**Meeting Date:** Tuesday 19 May 2015  
**Location:** Committee Room 2, Level 5, Civic Centre, 1 Devlin Street, Ryde  
**Time:** 5.00pm

**3 89 CULLODEN ROAD, MARSFIELD - LOT 9 DP 1046404. Development Application for a new two storey boarding house development comprising nine (9) boarding rooms under State Environmental Planning Policy (Affordable Rental Housing) 2009. LDA2014/0451.**

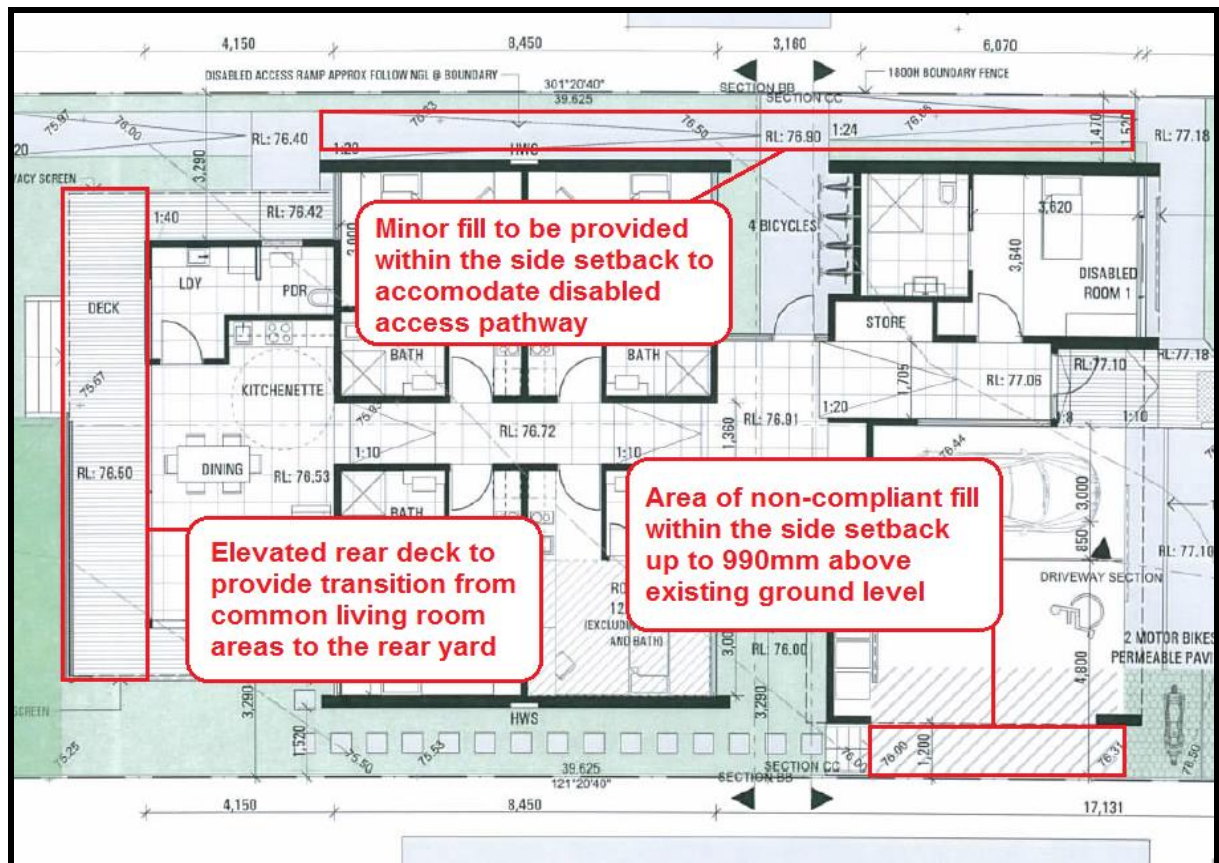
- The maximum fill within the building footprint (see **Figure 3** below) is not typical 'fill' associated with introduction of soil to the site, but rather an elevated deck to the rear of the site which acts as a transition from the boarding house to the rear private open space area. Located on the side elevations of this deck are privacy screens to reduce the potential for overlooking and subsequent loss of privacy to adjoining allotments.

**Figure 4** –This diagram shows small basement storage area located beneath the proposed boarding house which represents the maximum level of cut within the building footprint.  
Source: Submitted basement floor plan edited by CPS

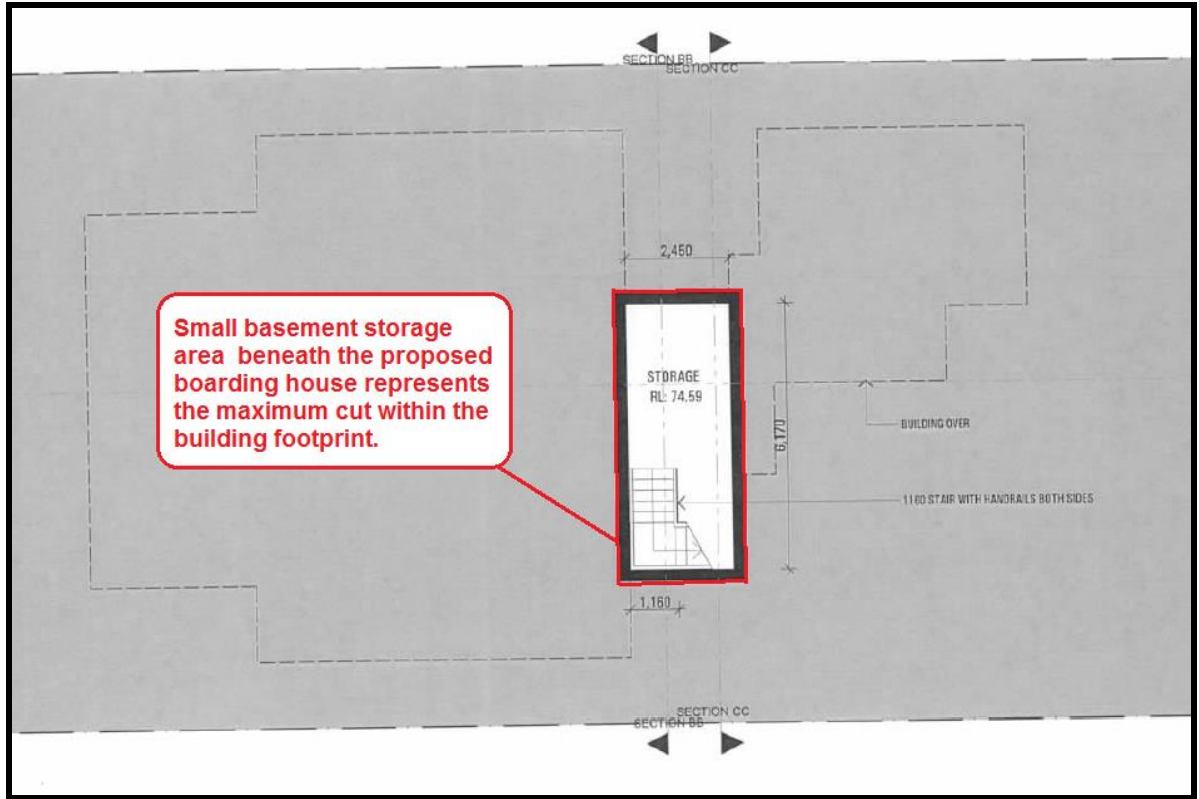
- The maximum cut within the building footprint (see **Figure 4** below) is entirely related to the basement storage area for the boarding house. This small area of approximately 15m<sup>2</sup> is not visible from the street, nor any adjoining property, and due to its modest size, it not considered to result in a significant modification to the site's overall topography.
- The maximum fill outside of the building footprint (see **Figure 3** below) relates to the shared parking zone for the disabled car parking space within the under croft garage area, and also partially within the side setback. Outside of the building footprint, this level of fill equates to an area of only 7.3m<sup>2</sup>, and as such is considered to be relatively minor.

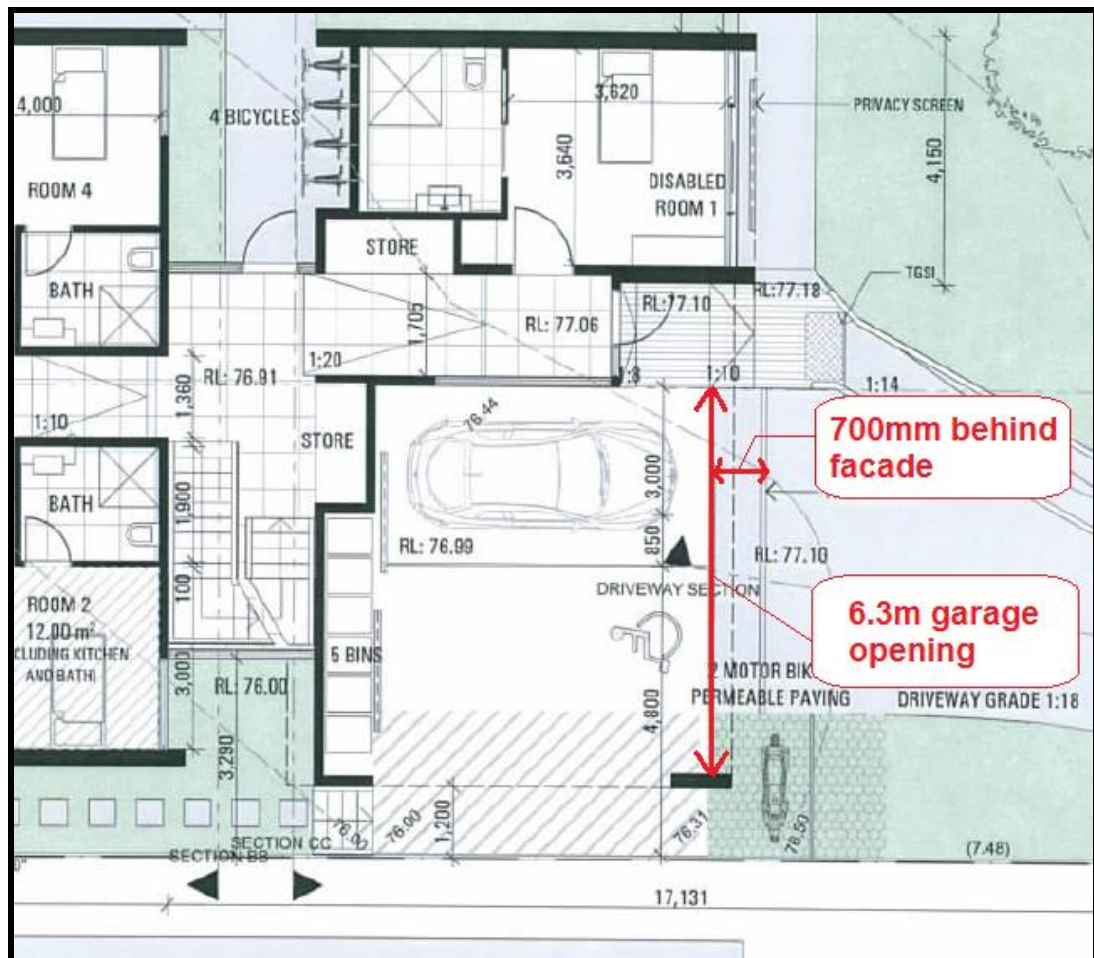
As assessment of the submitted architectural plans has revealed that proposed undercroft area of the dwelling which is to operate as the building's garage is located only 700mm behind the front façade, and has a garage opening facing the street of 6.3m (see **Figure 6** below).

- The proposal provides a compliant level of off-street car parking.
- The design of the undercroft parking area and design of the internal and external components of the development are such that the car parking arrangements on site are not prominent features with regard to either the individual lot or the streetscape.
- The undercroft parking arrangement is considered to be consistent with the contemporary design of the building.
